Project: Wickham Woolstore Development – Building 1

Report: Access Assessment Report

Reference No: 107528-Access-r1

Date: 15th March 2017

4.2.1 Drawings

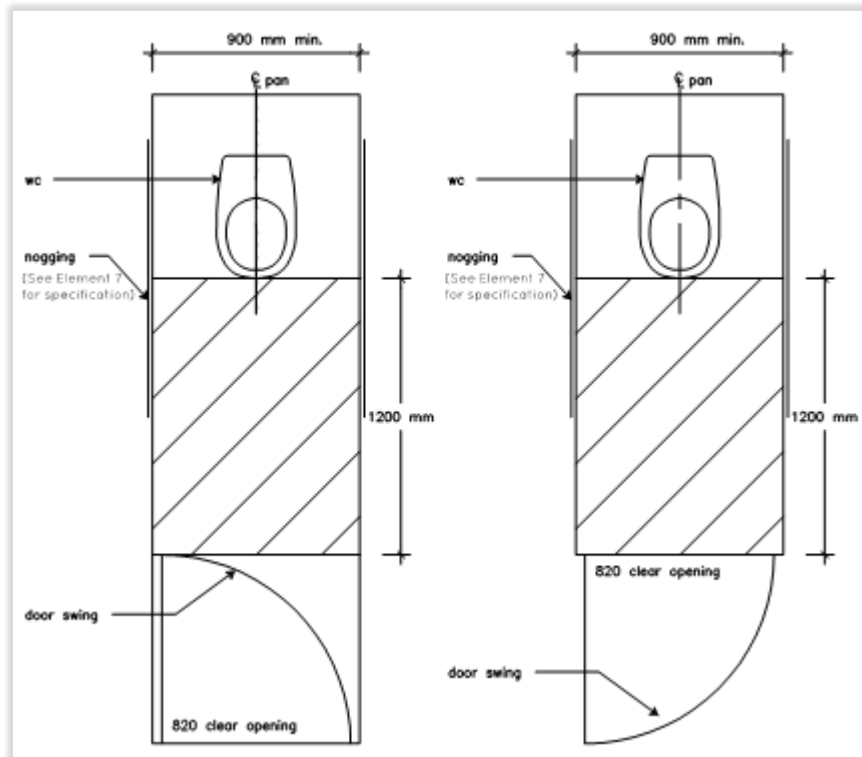
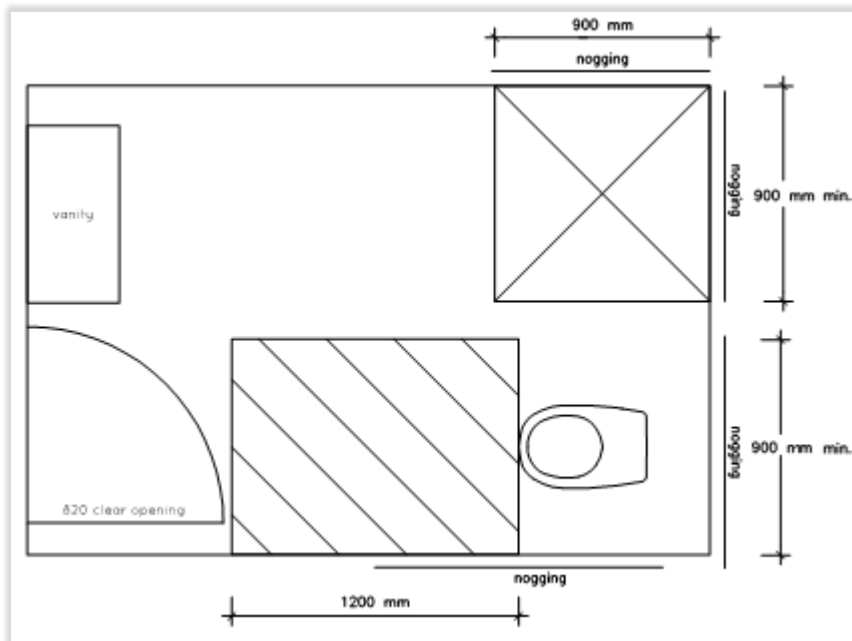
To allow assessment, the floorplan drawings will be required to be updated to identify the required 20% Livable housing sole occupancy units and be designed in compliance with LHDG silver level requirements.

4.2.5 Carpark

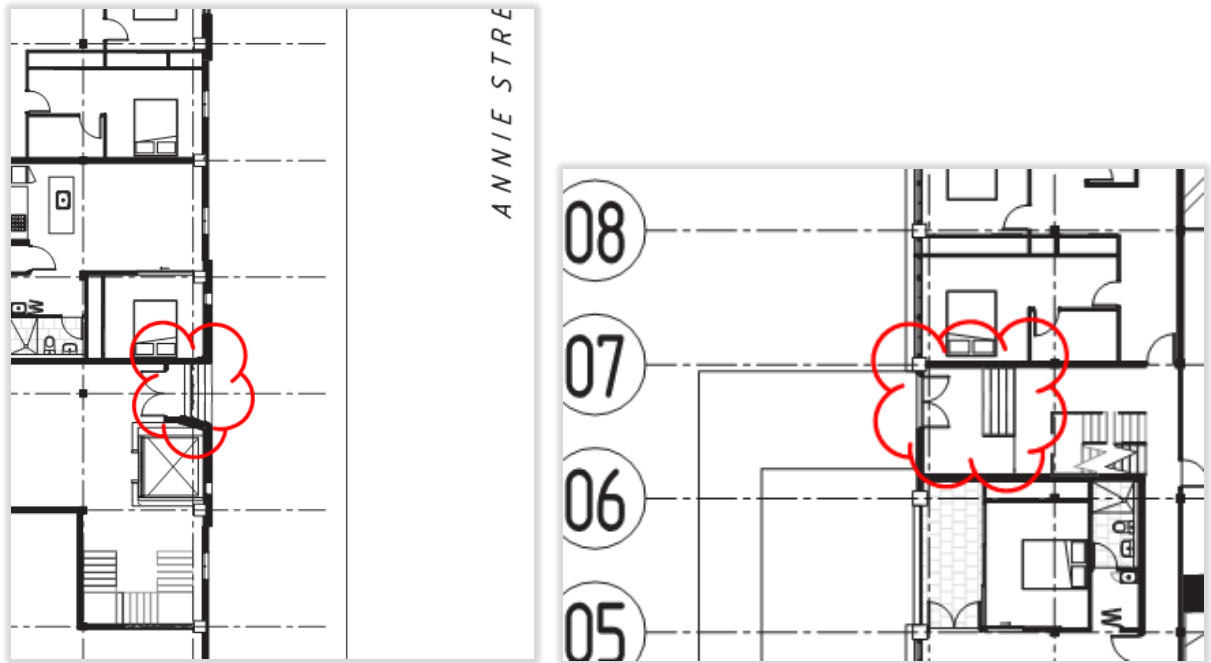
If any of the level 1 units containing an associated adjoining carpark are proposed to be Livable Apartments then the carparks are required to have increased internal dimensions as follows:-

- a. Where the parking area forms part of the dwelling access the space should incorporate:
 - i. minimum dimensions of at least 3200mm (width) x 5400mm (length);
 - ii. an even, firm and slip resistant surface; and
 - iii. a level surface (1:40 maximum gradient, 1:33 maximum gradient for bitumen).

4.3.2 Accessways – D3.3

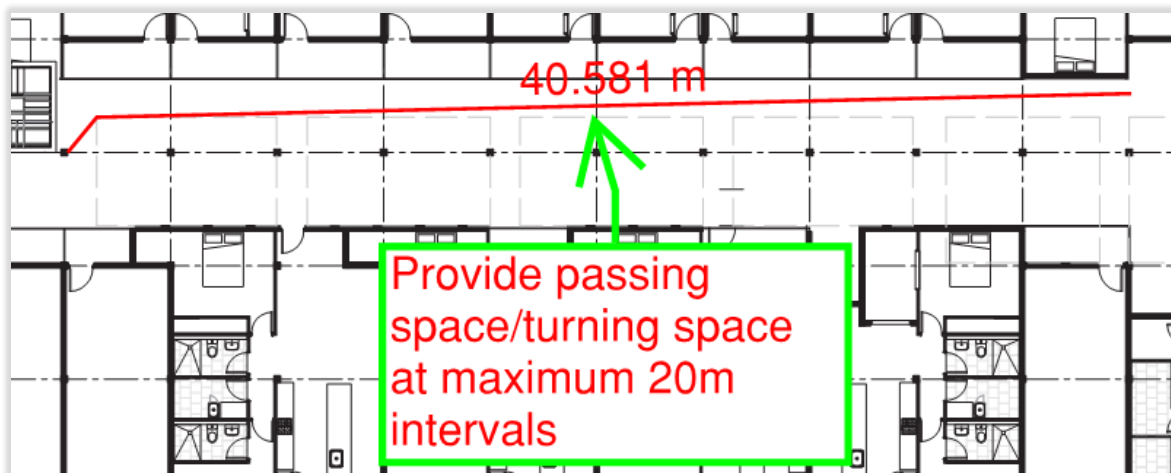
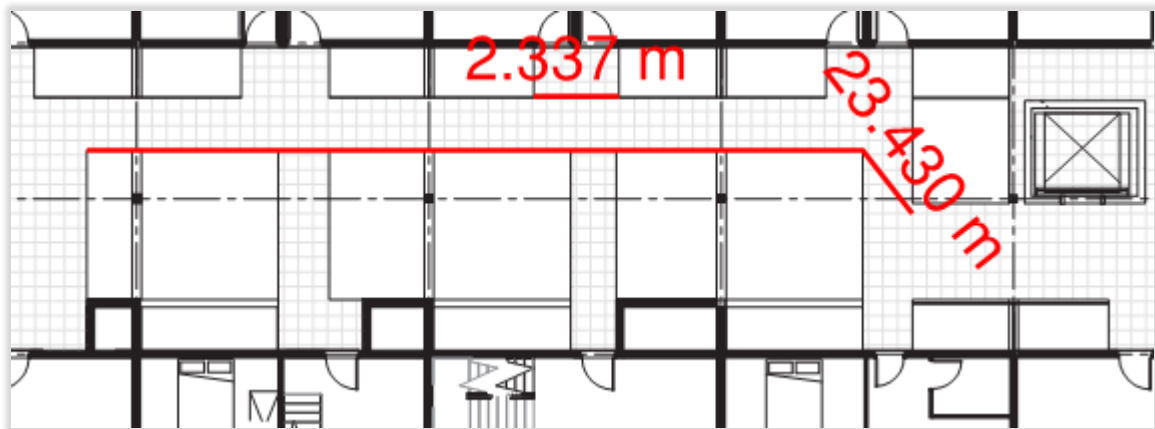
a. Provide a 1540 x2070mm turning bay within 2 metres of the end of all corridors in accordance with AS1428.1-2009.

There are multiple locations where this is an issue. Example location at level 1 below:-

b. Provide a passing space/turning space for wheelchairs at maximum 20 metre intervals in accordance with AS1428.1-2009.

Example locations below:-

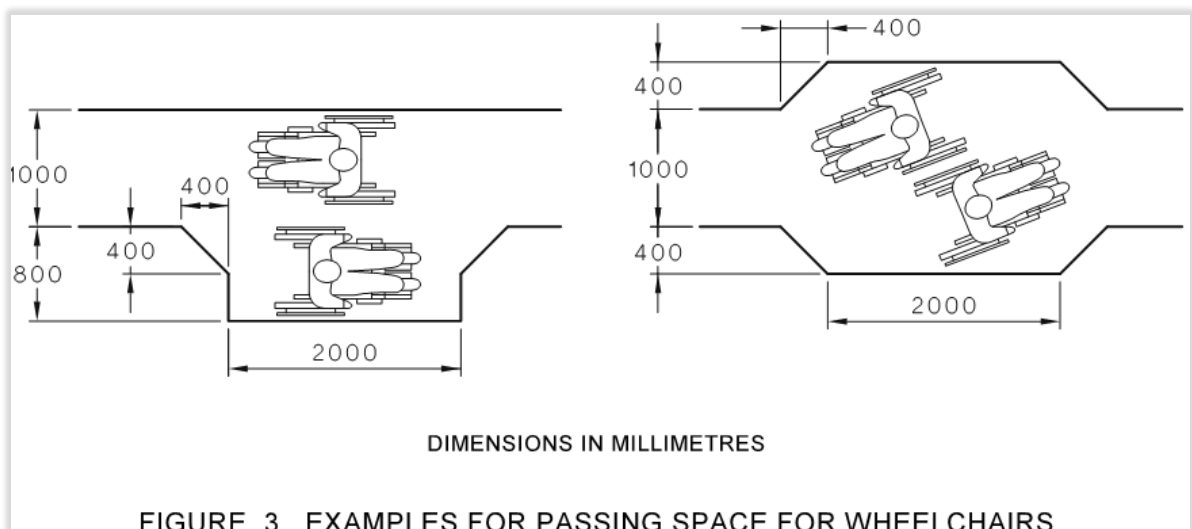
Redesign of all long corridors at levels 3 & 4 to include compliance with AS1428.1-2009 excerpt below:-

4.3.3 Stairs

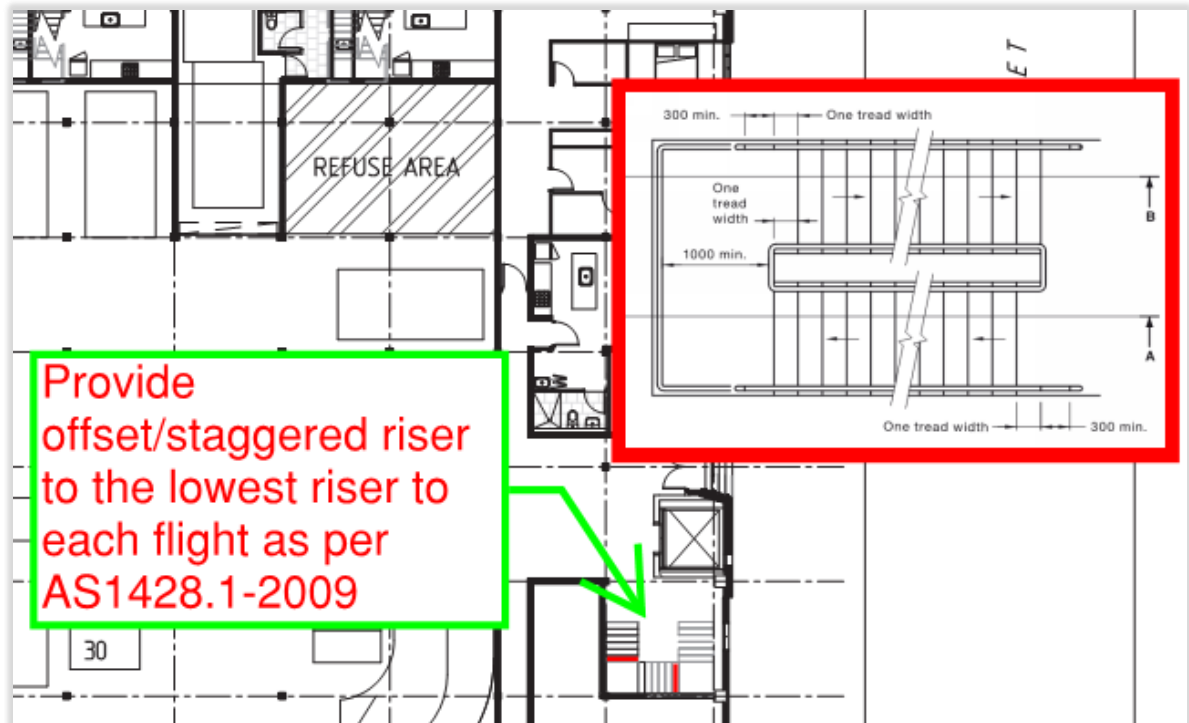
To all stairs, provide an off-set tread at stair base to allow continuous height handrail along the full stair flight, compliant with AS1428.1.

Note: this will result in the stair lengthening and stair shaft increase.

Example stair below:-
